Diagram 1 - 6402 Grapevine Bend Manvel, TX 77578

CERVELLE HOMES, INC. <small>P.O. BOX 1481 FREDERICKS, TEXAS 77848</small>		
DATE: 3-26-13	4RVPCW	PLAN # 4 CAR
DRAWING:	ELEVATION:	
LOCATION:		
SCALE: 1/8"=1'-0"

Diagram 2 - 6402 Grapevine Bend Manvel, TX 77578

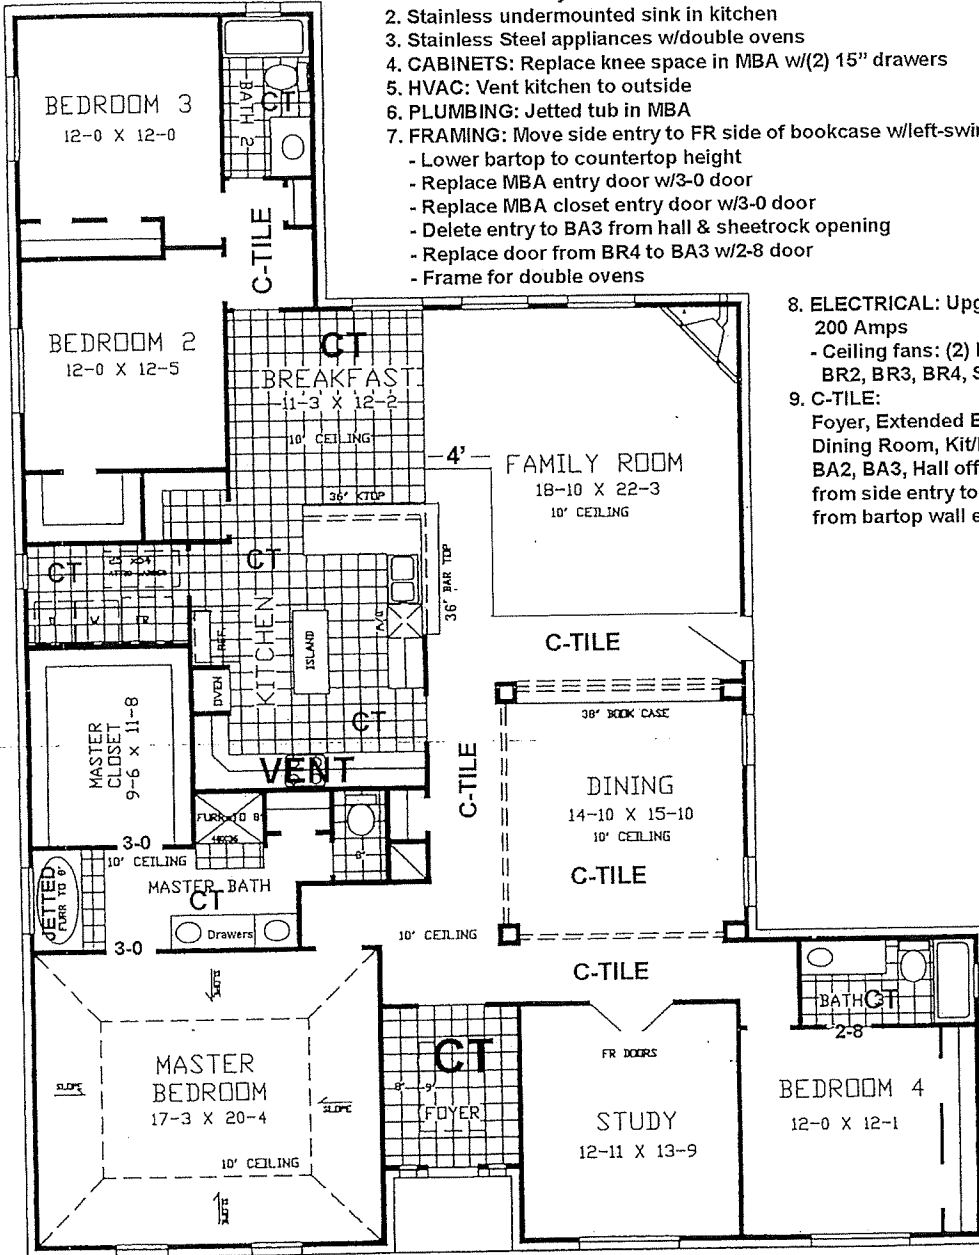
1. Manchester Ivory cabinets
2. Stainless undermounted sink in kitchen
3. Stainless Steel appliances w/double ovens
4. CABINETS: Replace knee space in MBA w/(2) 15" drawers
5. HVAC: Vent kitchen to outside
6. PLUMBING: Jettied tub in MBA
7. FRAMING: Move side entry to FR side of bookcase w/left-swing
  - Lower bartop to countertop height
  - Replace MBA entry door w/3-0 door
  - Replace MBA closet entry door w/3-0 door
  - Delete entry to BA3 from hall & sheetrock opening
  - Replace door from BR4 to BA3 w/2-8 door
  - Frame for double ovens

8. ELECTRICAL: Upgrade service to 200 Amps
  - Ceiling fans: (2) FR, (1) each MBR, BR2, BR3, BR4, Study

9. C-TILE:
  - Foyer, Extended Entry, Hall off Din, Dining Room, Kit/bkfst, Util, MBA, BA2, BA3, Hall off bedrooms, from side entry to kitchen, from bartop wall extend 4' into FR
